TECHNICAL BULLETIN

CHANGE OF OEM SAF SKRS BRAKE DRUM DESIGN

OEM PART No.: 1064026000, 1064026001, 1064026002, 1064026012, 10640260020 & 106402700

WINNARD PART Numbers.: SAU1011 & SAU1013

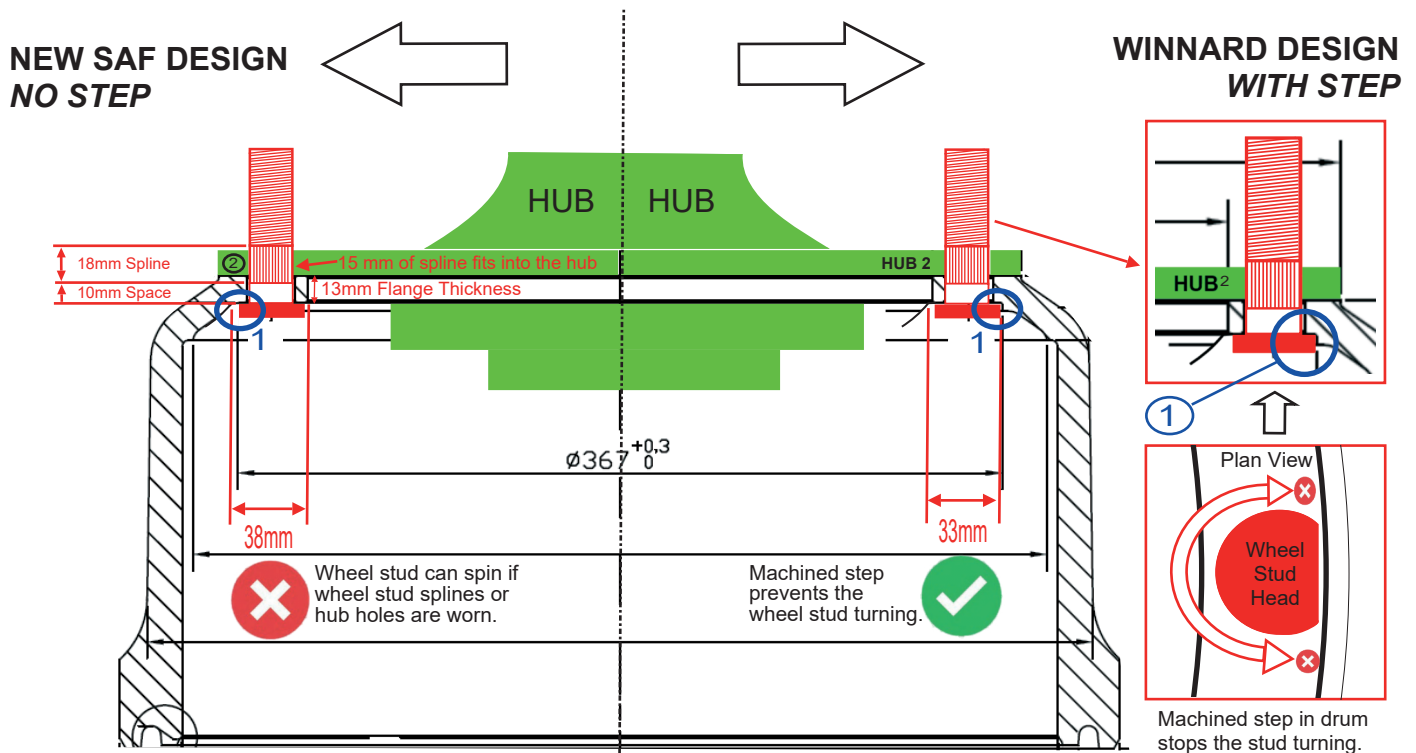
SAF has changed the design of this brake drum. The stud location step on the underside of the stud face has been removed, see area (1) in the illustration below. The wheel stud is designed to have an interference fit into the hub (2). The location step in the old brake drum design helped to prevent the wheel stud from rotating as its interference fit into the hub loses resistance.

We understand this change has been made to prevent unsuitable, worn, components from being re-used.

Winnard will continue to supply the old design with the stud location step but the new design is also available, our part number is SAU1011NS & SAU1013NS.
